ESE REVIEW OF ALTERNATE PLAN  
1"=200'  
7/08/2026

Bennett Farm Development  
SR 401 Conestoga Road Alternate Access Option  
West Vincent Township,  
Chester County, Pennsylvania  
June 11, 2026

| CONNECTION TO CONESTOGA ROAD EXHIBIT<br>ROAD D PROFILE (BOLES SMYTH) |                                  | <b>BENNETT PROPERTY</b><br>WEST VINCENT TOWNSHIP, CHESTER COUNTY, PENNSYLVANIA |               |

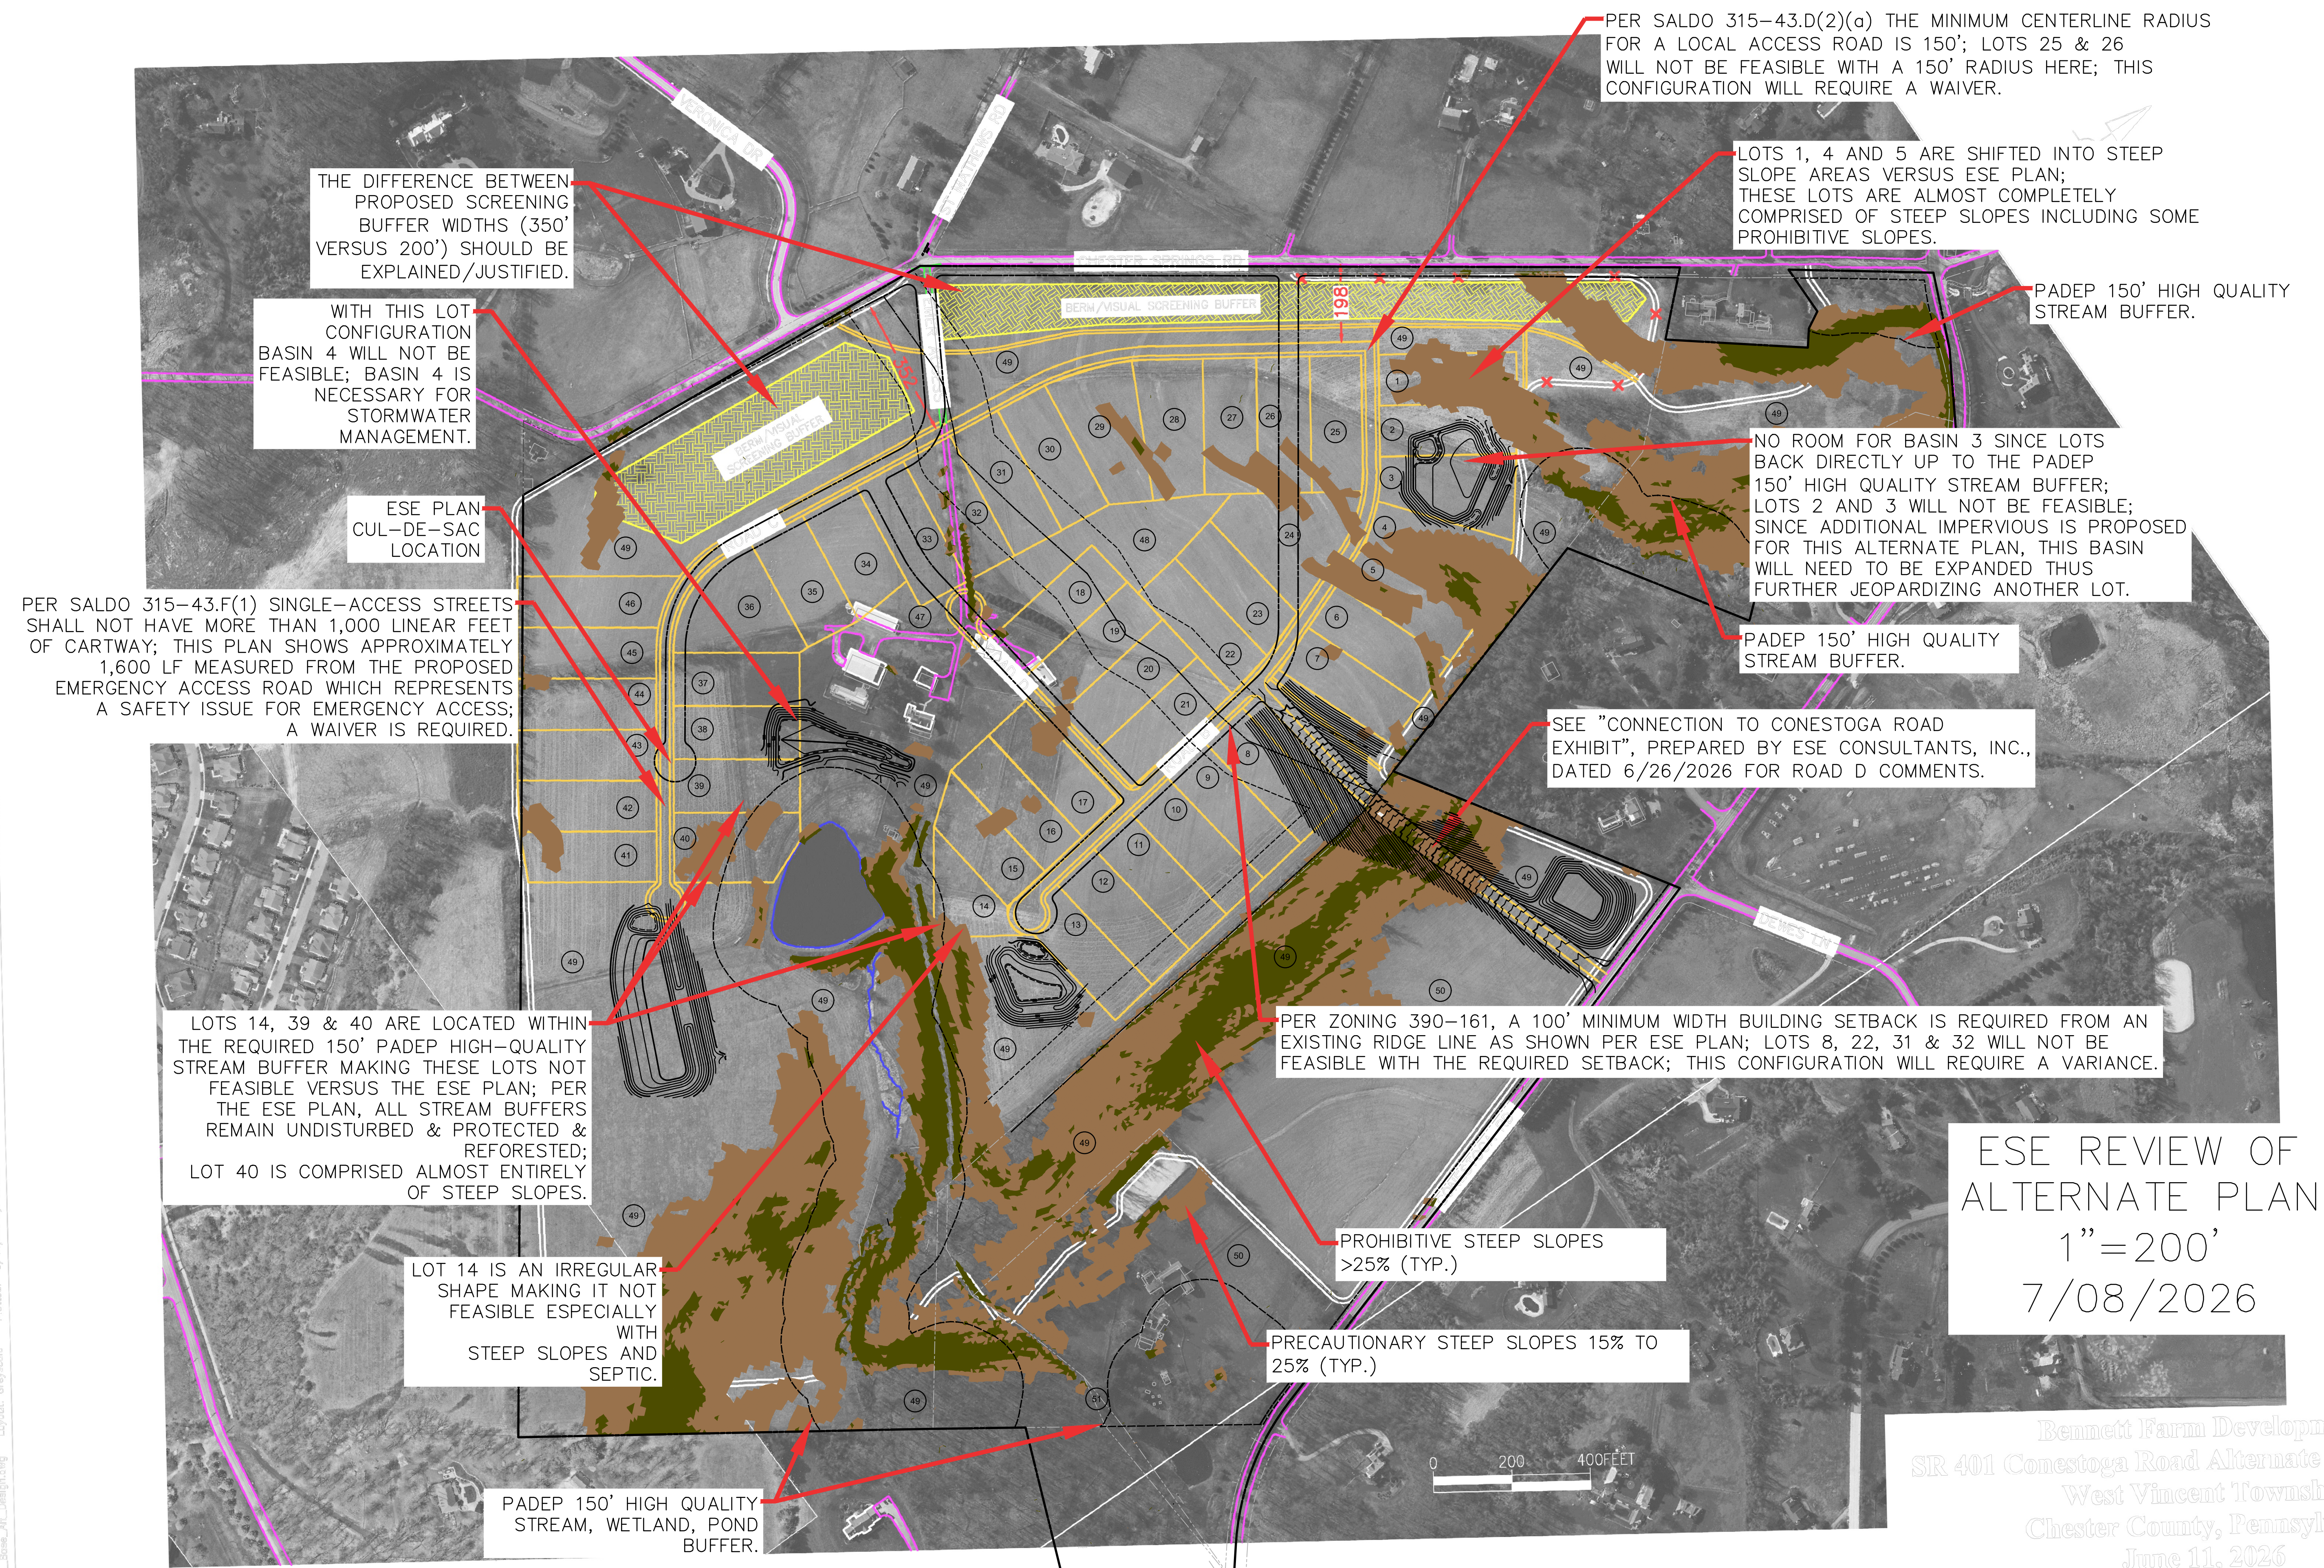
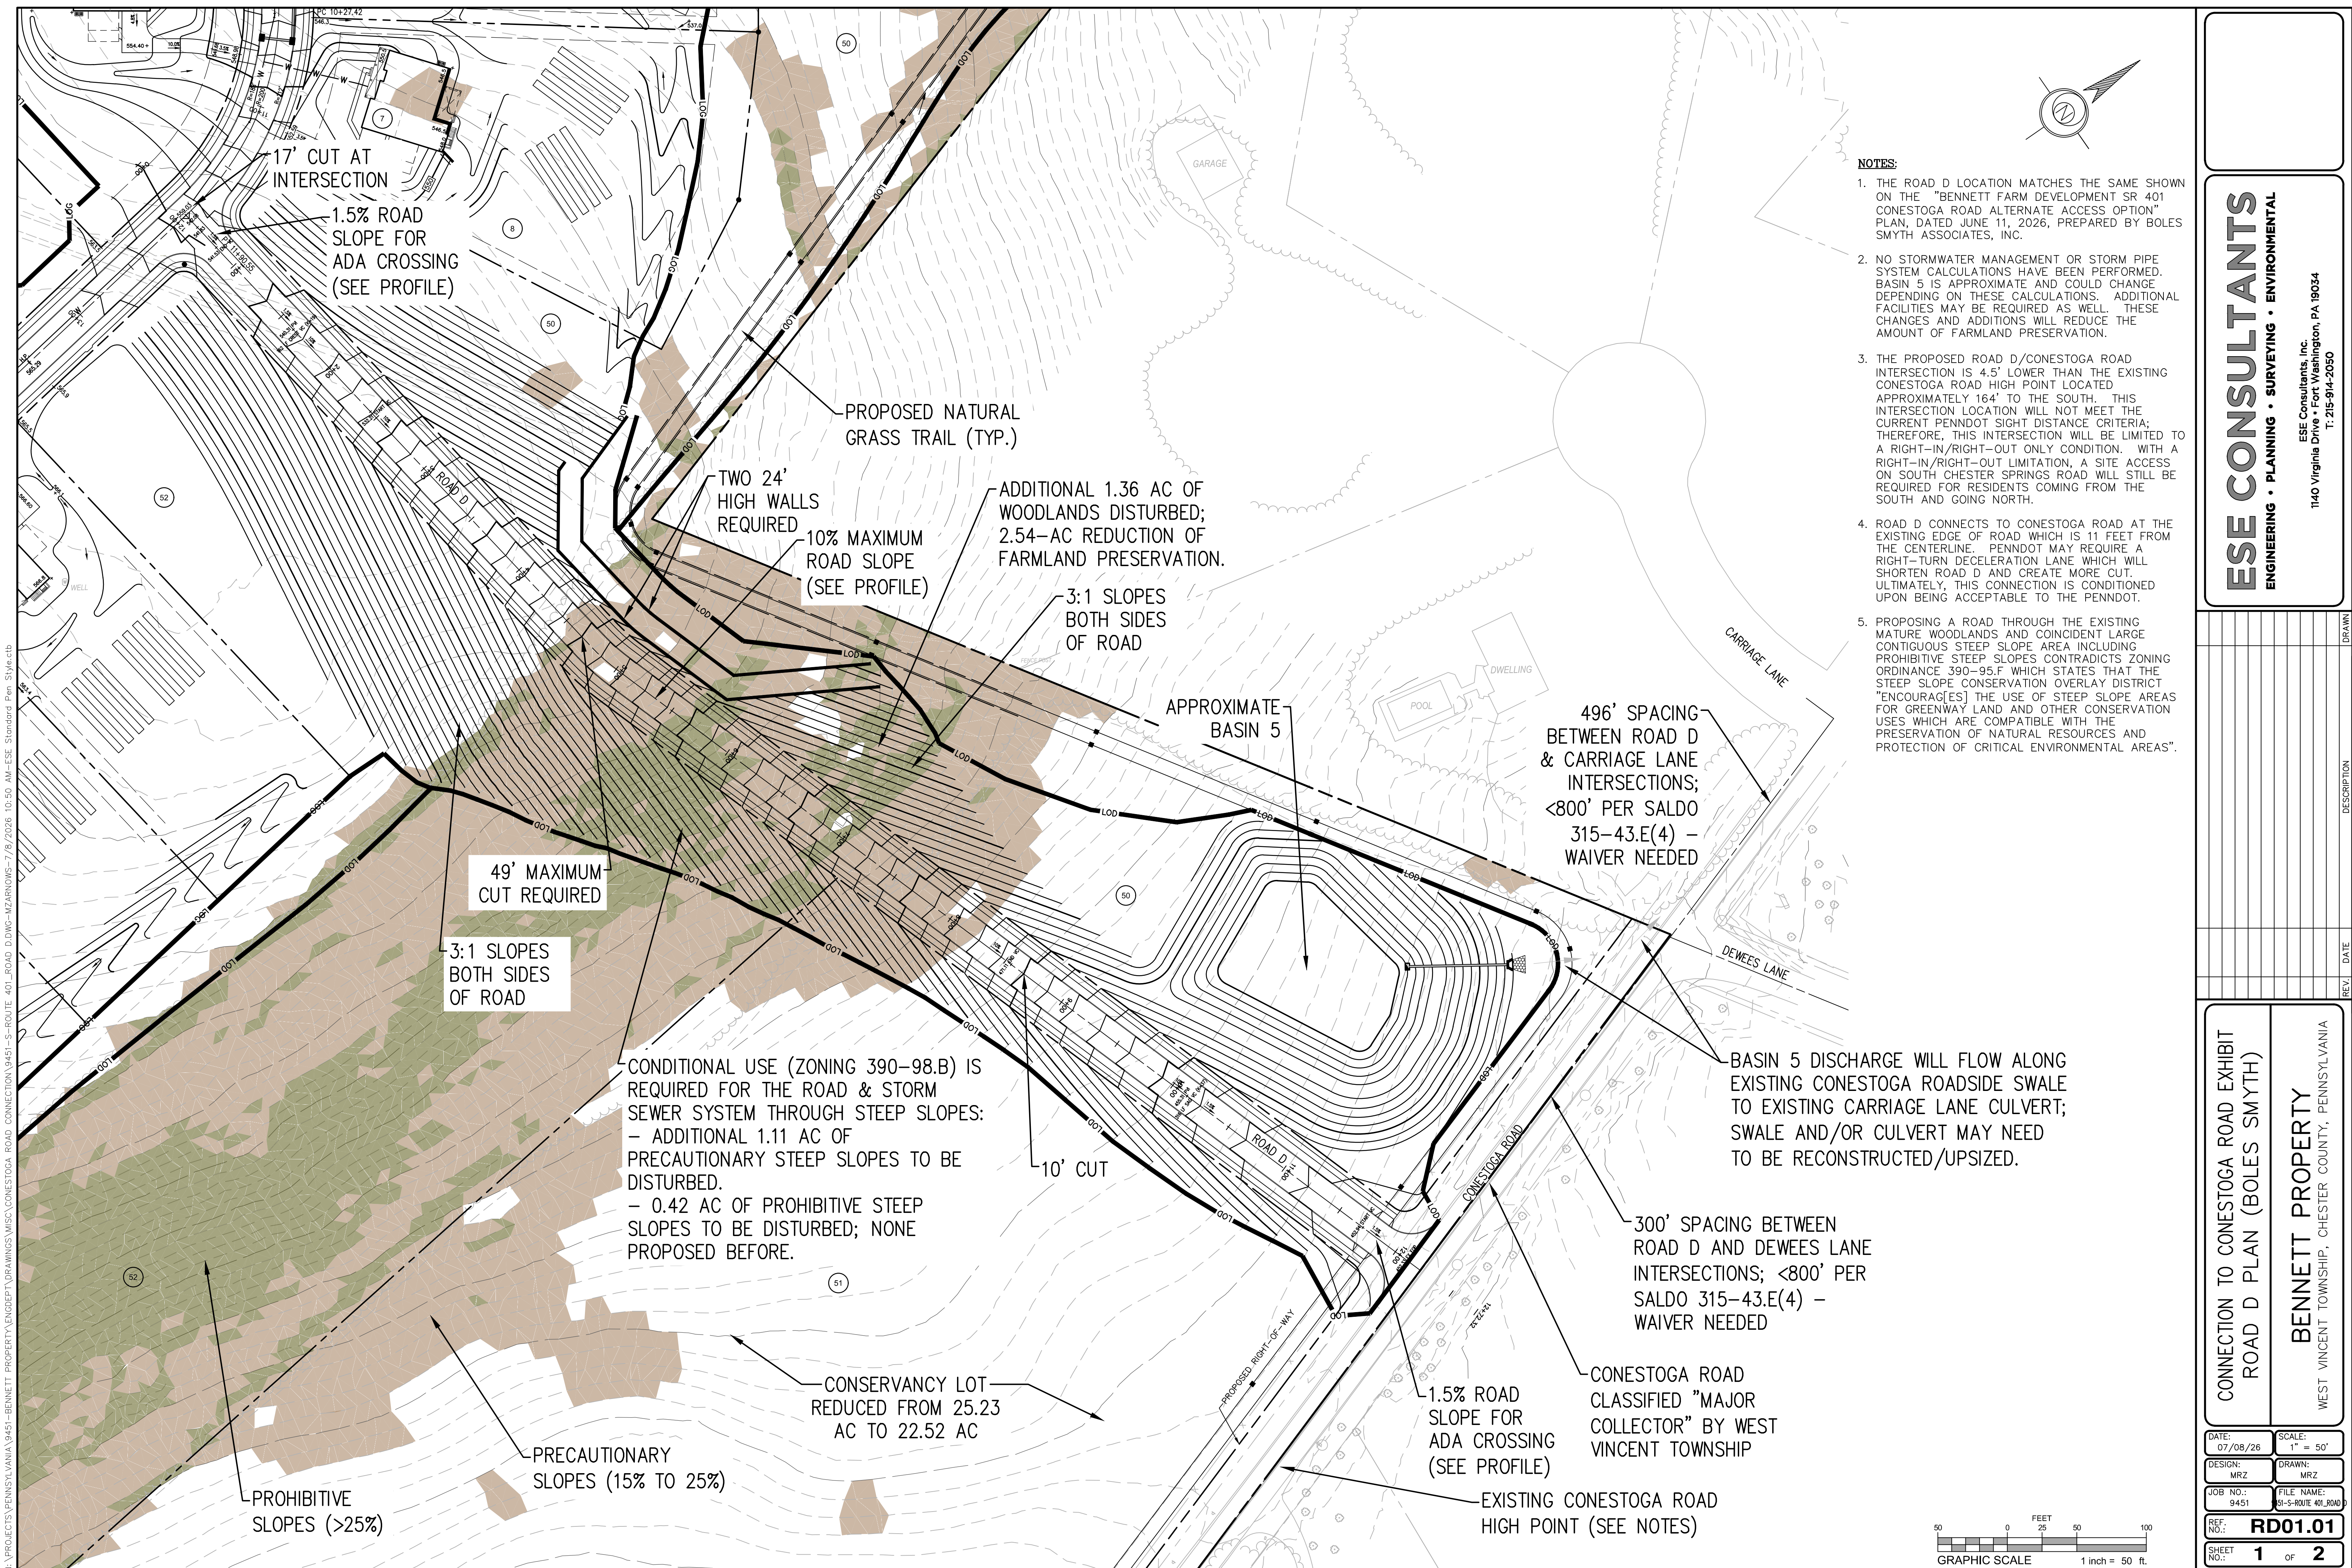
THE DIFFERENCE BETWEEN PROPOSED SCREENING BUFFER WIDTHS (350' VERSUS 200') SHOULD BE EXPLAINED/JUSTIFIED.

WITH THIS LOT CONFIGURATION BASIN 4 WILL NOT BE FEASIBLE; BASIN 4 IS NECESSARY FOR STORMWATER MANAGEMENT.

PER SALDO 315-43.F(1) SINGLE-ACCESS STREETS SHALL NOT HAVE MORE THAN 1,000 LINEAR FEET OF CARTWAY; THIS PLAN SHOWS APPROXIMATELY 1,600 LF MEASURED FROM THE PROPOSED EMERGENCY ACCESS ROAD WHICH REPRESENTS A SAFETY ISSUE FOR EMERGENCY ACCESS; A WAIVER IS REQUIRED.

LOTS 14, 39 & 40 ARE LOCATED WITHIN THE REQUIRED 150' PADEP HIGH-QUALITY STREAM BUFFER MAKING THESE LOTS NOT FEASIBLE VERSUS THE ESE PLAN; PER THE ESE PLAN, ALL STREAM BUFFERS REMAIN UNDISTURBED & PROTECTED & REFORESTED; LOT 40 IS COMPRISED ALMOST ENTIRELY OF STEEP SLOPES.

LOT 14 IS AN IRREGULAR SHAPE MAKING IT NOT FEASIBLE ESPECIALLY WITH STEEP SLOPES AND SEPTIC.

PER SALDO 315-43.D(2)(a) THE MINIMUM CENTERLINE RADIUS FOR A LOCAL ACCESS ROAD IS 150'; LOTS 25 & 26 WILL NOT BE FEASIBLE WITH A 150' RADIUS HERE; THIS CONFIGURATION WILL REQUIRE A WAIVER.

LOTS 1, 4 AND 5 ARE SHIFTED INTO STEEP SLOPE AREAS VERSUS ESE PLAN; THESE LOTS ARE ALMOST COMPLETELY COMPRISED OF STEEP SLOPES INCLUDING SOME PROHIBITIVE SLOPES.

NO ROOM FOR BASIN 3 SINCE LOTS BACK DIRECTLY UP TO THE PADEP 150' HIGH QUALITY STREAM BUFFER; LOTS 2 AND 3 WILL NOT BE FEASIBLE; SINCE ADDITIONAL IMPERVIOUS IS PROPOSED FOR THIS ALTERNATE PLAN, THIS BASIN WILL NEED TO BE EXPANDED THUS FURTHER JEOPARDIZING ANOTHER LOT.

PER ZONING 390-161, A 100' MINIMUM WIDTH BUILDING SETBACK IS REQUIRED FROM AN EXISTING RIDGE LINE AS SHOWN PER ESE PLAN; LOTS 8, 22, 31 & 32 WILL NOT BE FEASIBLE WITH THE REQUIRED SETBACK; THIS CONFIGURATION WILL REQUIRE A VARIANCE.
